STAFF REPORT

REGIONAL CENTER HEARING EXAMINER - HIGH IMPACT CASE

Case Number	2023-REG-063
Address (approx.)	916, 918 and 922 North Capitol Avenue and 217 West 10 th Street
Location	Center Township, Council District # 11
Petitioner	MTP – 922 N. Capitol Ave., LLC, by Joseph D. Calderon
Zoning	CBD-2 (RC) and I-3 (RC) (CBD-2 (RC) pending)
Request	Regional Center Approval for adaptive re-use of Stutz II building, demolition of existing non-historic buildings and construction of a five-story building and a six-story building, for a mixed-use development, with approximately 278 units, 26,571 square feet of leased office and retail space, 7,505 square feet of amenity space, a parking garage with approximately 358 spaces, and an outdoor courtyard.

LANDSCAPE | OVERALL PLAN

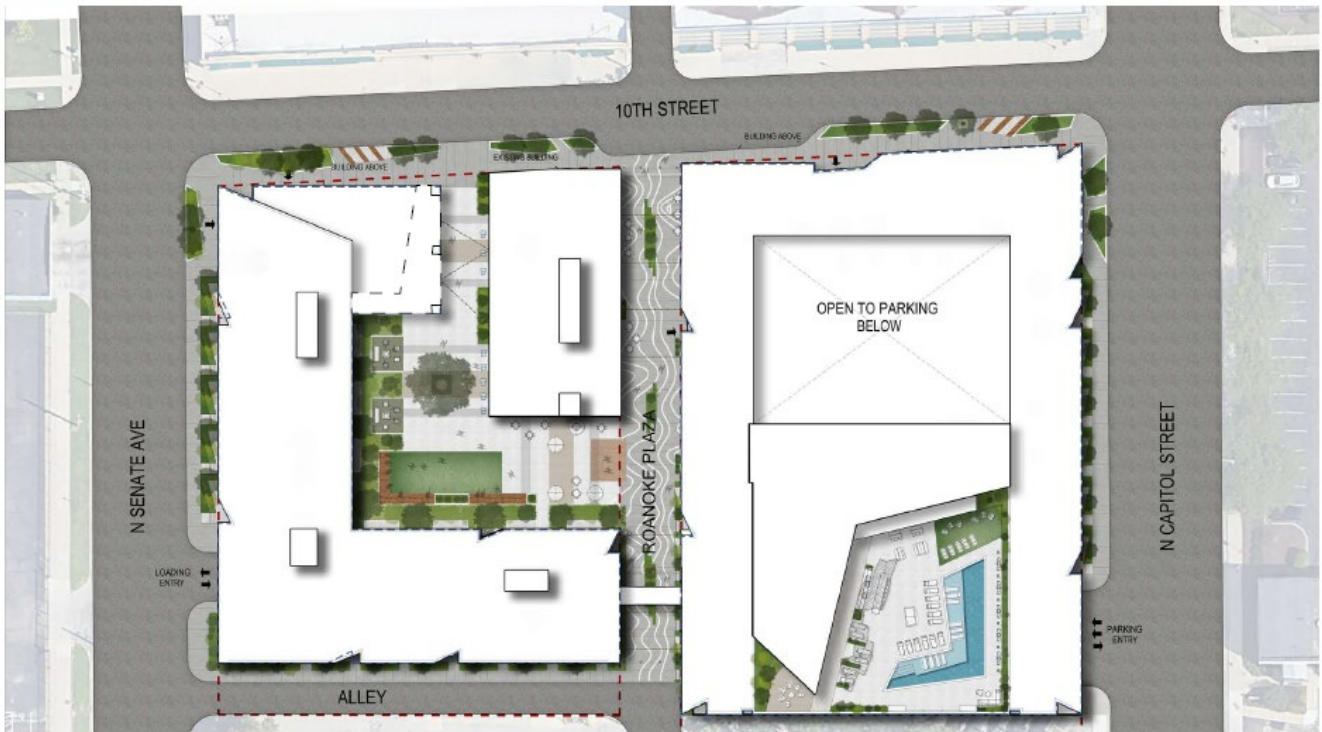
3. A Landscape plan was submitted, but it does not detail the plantings. A landscape plan shall be submitted for staff review and approval prior to issuance of an Improvement Location Permit. Guidelines US 1.3.2, CA 4.6.1, CA 4.6.4, and CA 4.6.6 would apply.
